**WASILLA PLANNING COMMISSION  
RESOLUTION SERIAL NO. 20-17**

**A RESOLUTION OF THE WASILLA PLANNING COMMISSION APPROVING PLANNED UNIT DEVELOPMENT #20-02 TO AMEND PLANNED UNIT DEVELOPMENT (PUD) #05-01 TO REVISE THE PROPOSED DEVELOPMENT SCHEDULE OF PROPOSED USES BY REMOVING THE REQUIREMENT FOR A MIXED-USE DEVELOPMENT AND ALLOWING THE REMAINDER OF THE PROJECT TO BE DEVELOPED WITH 46 RESIDENTIAL DWELLING UNITS AND A 1,050 SQUARE FEET COMMERCIAL BUILDING IN TWO PHASES, LOCATED ON LOT 1, BLOCK 1 AND LOT 1, BLOCK 2, YENLO SQUARE SUBDIVISION.**

**EXHIBIT A**  
**Wasilla Planning Commission Resolution 20-17**  
**FINDINGS OF FACT – Section 16.16.070, Rezoning**

**CIVIL SITE & UTILITY IMPROVEMENTS**  
**YENLO PHASE II PLANNED UNIT DEVELOPMENT**  
**OVERALL SITE PLAN**

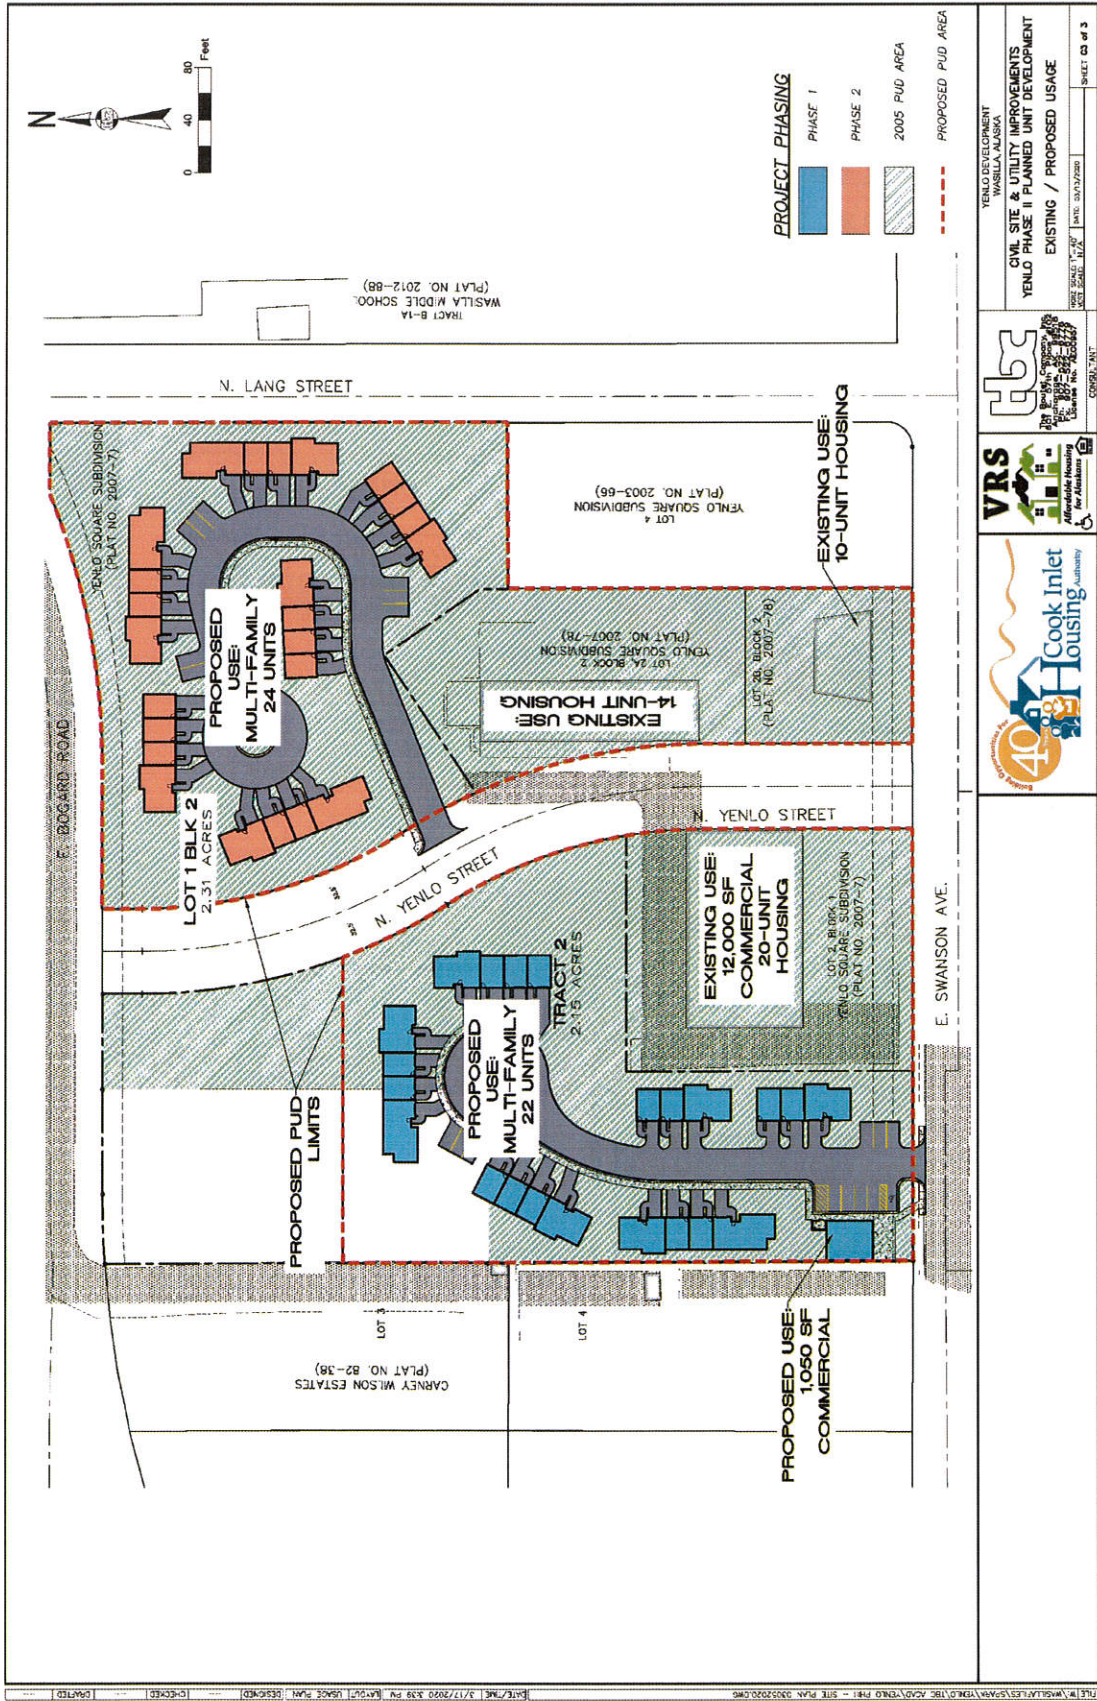
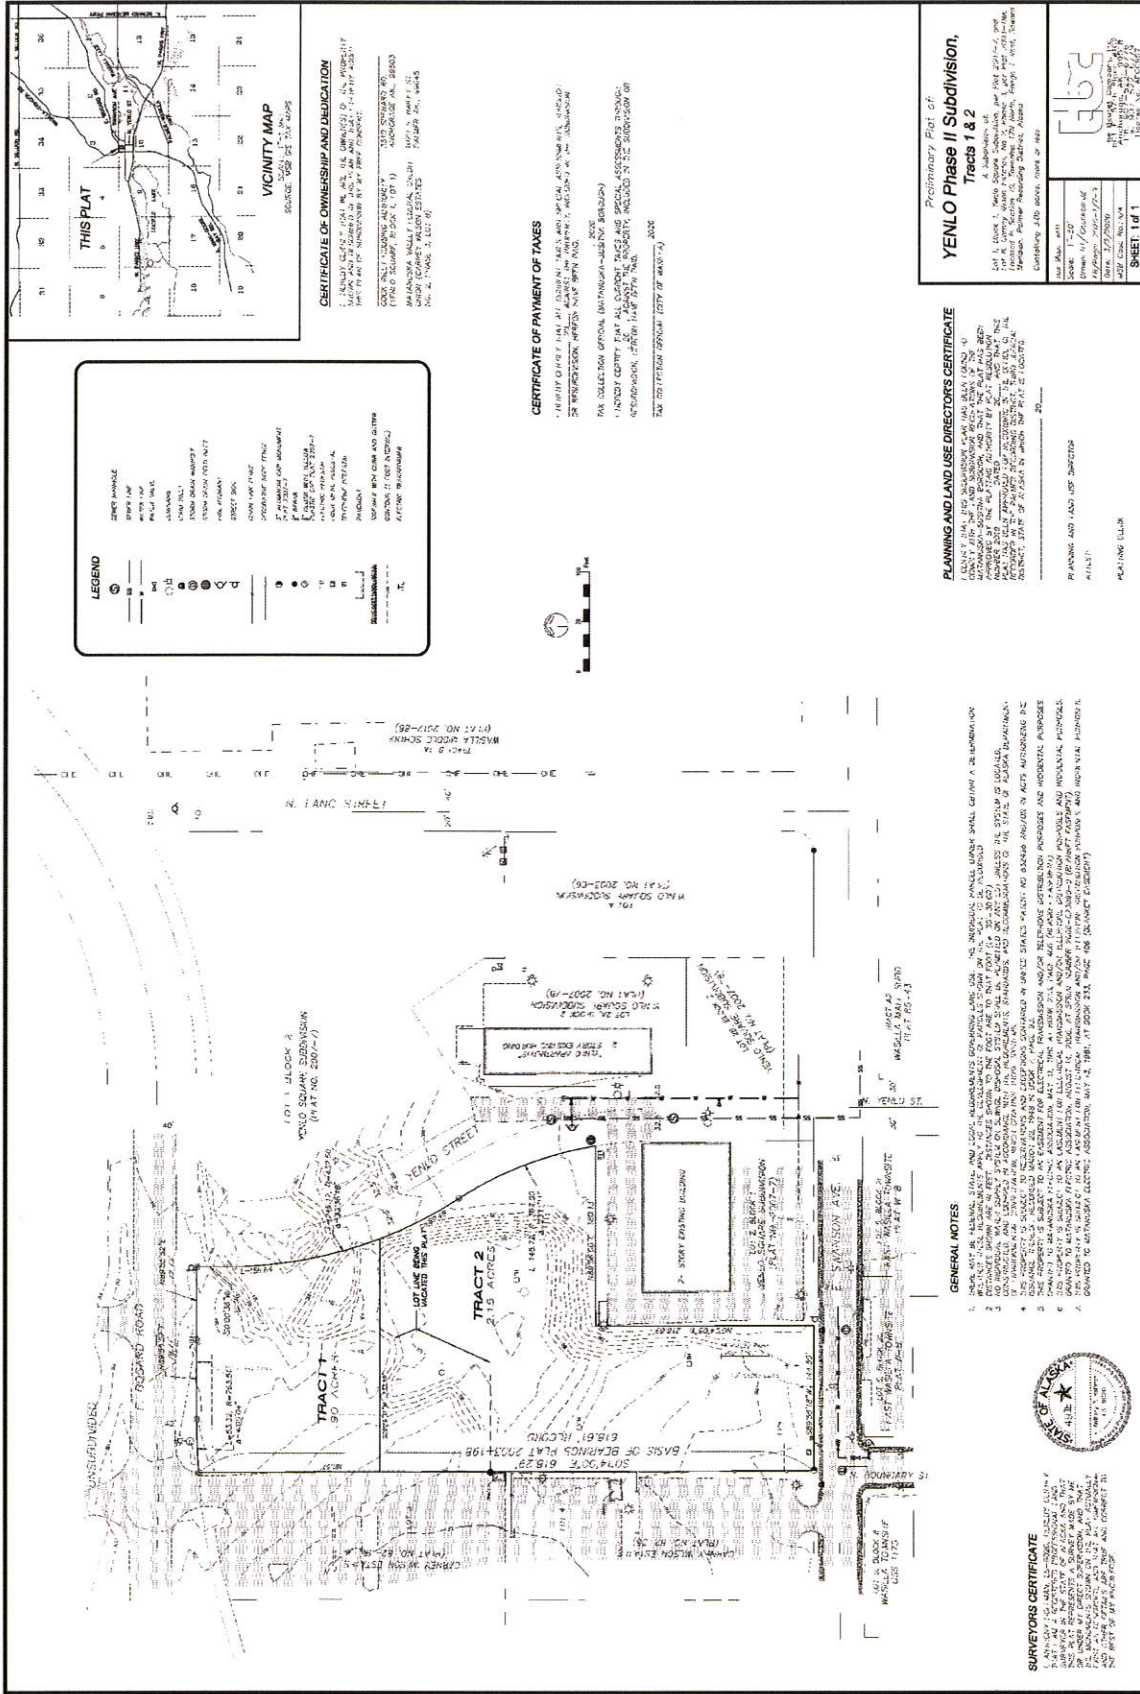
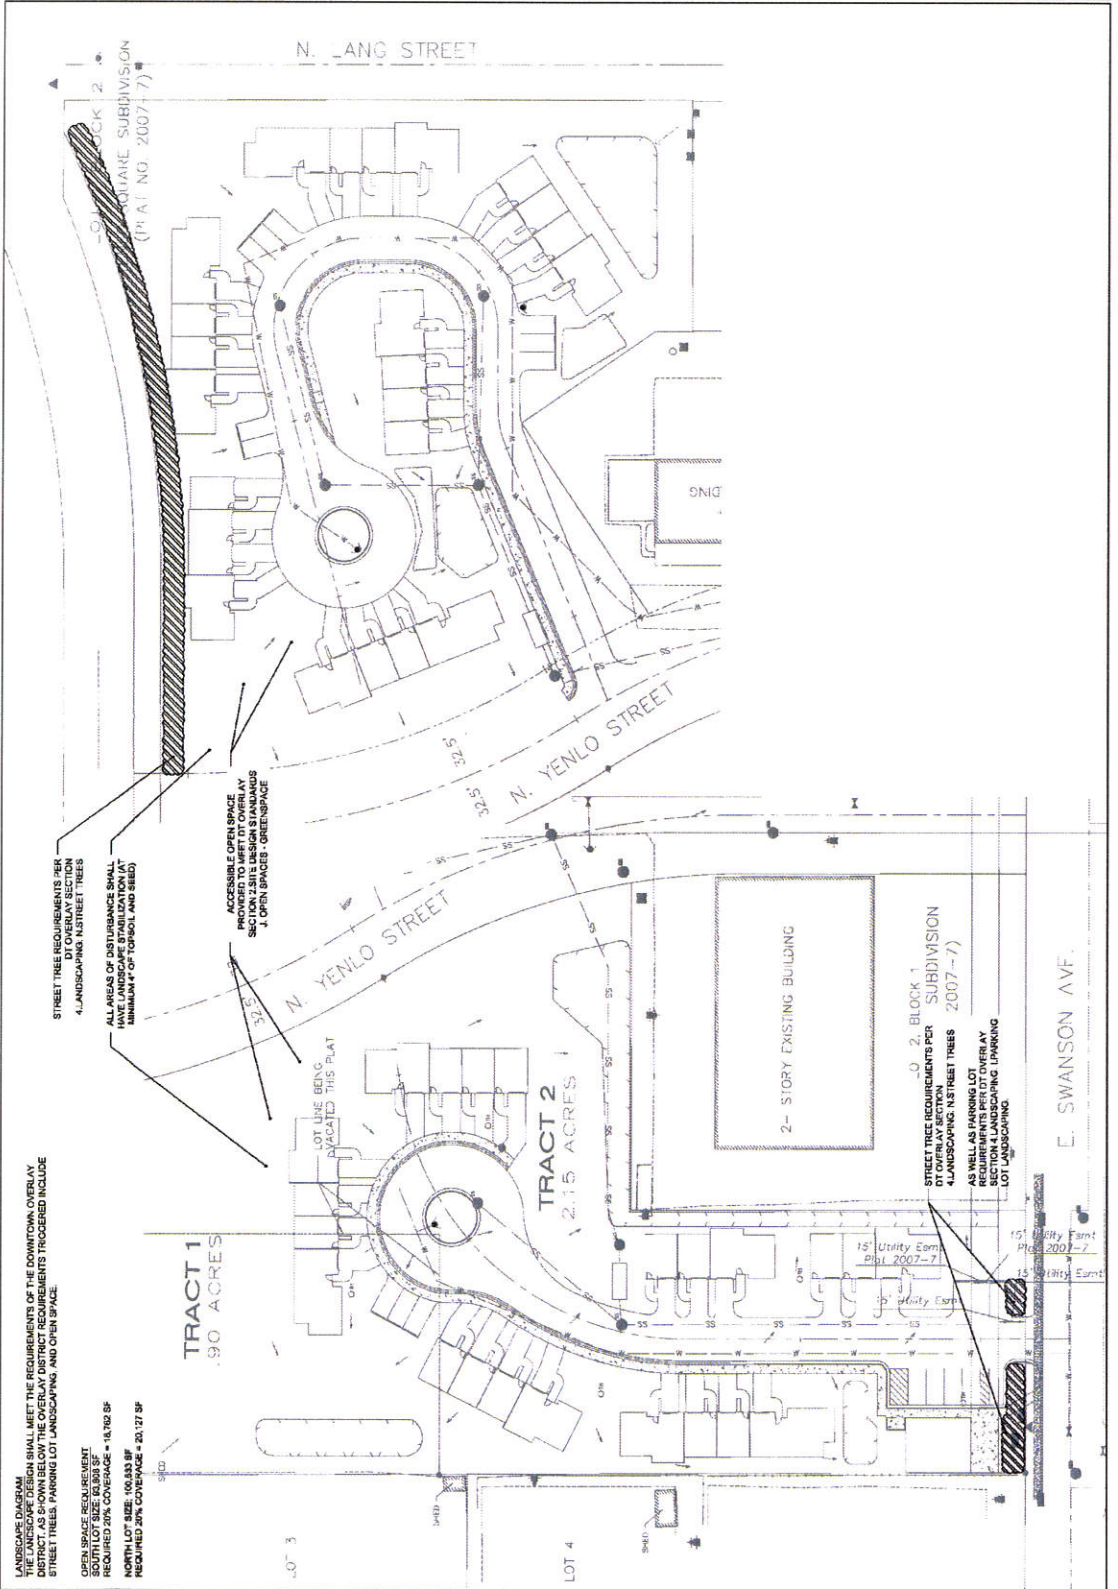
Finding: The proposed PUD provides adequate building separation and parking areas. However, there is not adequate pedestrian and bicycle access. A condition of approval is adopted that requires the applicant to submit a revised site plan to the City Planner for review and inclusion in the City Council packet that provides internal sidewalk connectivity among the different uses within the PUD, a sidewalk along the northern property line of Phase II (Bogard Road) between Yenlo Street and Lang Street, and a

However, the proposed design does not provide adequate protection to the residential units to mitigate the negative noise and visual impacts from the surrounding commercial, educational, and government uses. Although the landscaping regulations do not require a new residential development to provide screening/ buffering when adjacent to existing adjoining commercial uses, buffering should be provided by the developer to protect the residences.

Finding: The proposed open space does not contain any amenities or recreational opportunities for the residents other than the provision of four picnic tables on an uncovered concrete patio for each phase.

Finding: The proposed development meets the building height and landscape/open space requirements. However, Building UG2 and the commercial building do not meet the minimum 10' side yard setback. However, the reduced side yard setback is permitted in the Commercial zoning provided that the Borough Fire Marshal reviews and approves the setback. Also, Buildings UG1 And UG2 exceed the maximum setback allowed in the Downtown Overlay. The applicant is seeking a variance to the requirement as part of the PUD approval process.

- a. Internal sidewalk connectivity among the different uses within the PUD, a sidewalk along the northern property line of Phase II (Bogard Road) between Yenlo Street and Lang Street, and a connection to the existing pathway located within the undeveloped Lang Street right-of-way (east lot line).

- b. Enhanced interior landscaping to make the site more visually appealing (e.g. street trees along the driveways for each unit – see initial landscape plan submitted with application), individual decks and/or fenced yards to provide privacy (where feasible) and outdoor seating/gathering areas for each phase that includes one or more of the following amenities: community areas with covered picnic/grilling areas, playgrounds, or other similar uses.

- c. Installation of a minimum six-foot tall wooden fence or wall along the length of the western lot line extending from the northwest corner of the lot to the northern edge of the proposed commercial building to the south.

- d. Installation of a minimum six-foot tall wooden fence or wall along the entire length of the eastern lot line.
  - e. Installation of a minimum six-foot tall wooden fence or wall supplemented with evergreen trees on the interior of the fence.
